15 - SPECIAL TOOLS

Creation of special tools: 7.0145 F
7.0606 F2Y
7.0615 EY-K
7.0910 E
8.0911 A2

Workshop reference : 7.0910 E — Spring compression plate

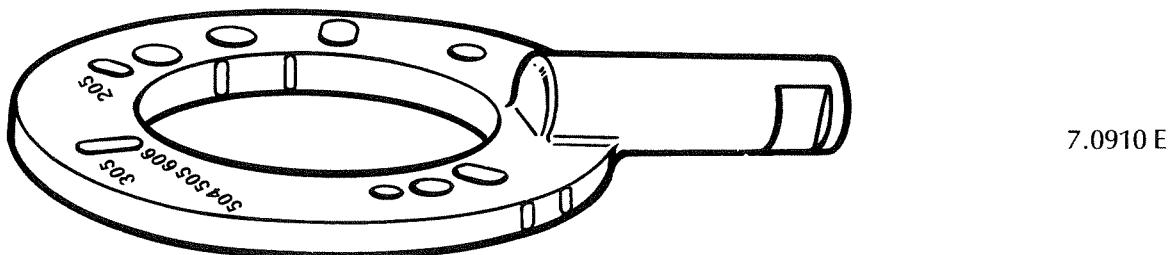
Purpose : The introduction of struts with inclined springs on 504/505 has made this plate necessary
It has been designed to allow completely safe removal of 205 — 305 series II and all 504 — 505 — 604 front springs

This kit thus modified becomes: 8.0910 ZW

Workshop reference : 8.0911 A2 Set of 2 supports

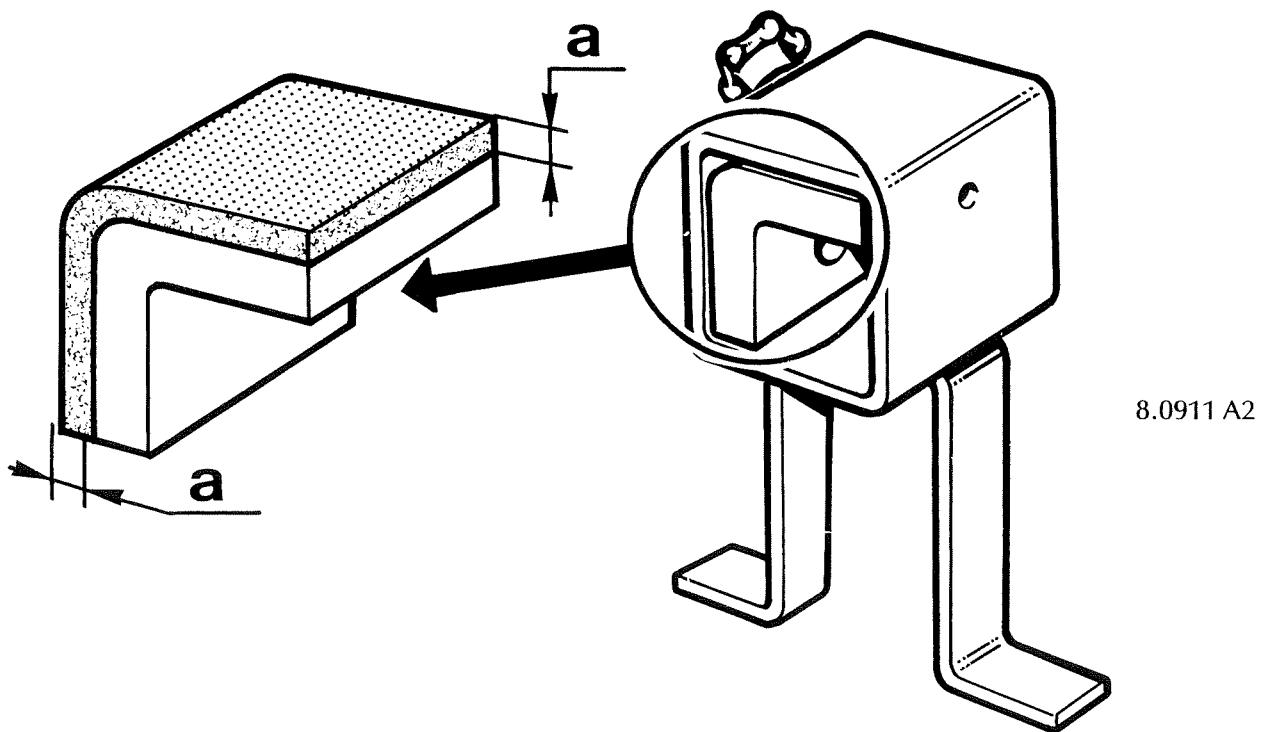
a: part to be removed if necessary

Square-section cross bars existing in the dealer network have a flat dimension of either 35 or 50mm, depending on whether they are of PEUGEOT or TALBOT origin. Consequently, on receipt of the set of two supports the aluminium spacers should be adapted to suit the bar size, so that the bar will slide with a small clearance. The spacers are not necessary for the 50mm x 50mm bars.

The assembly thus modified becomes 8.0911 ZY
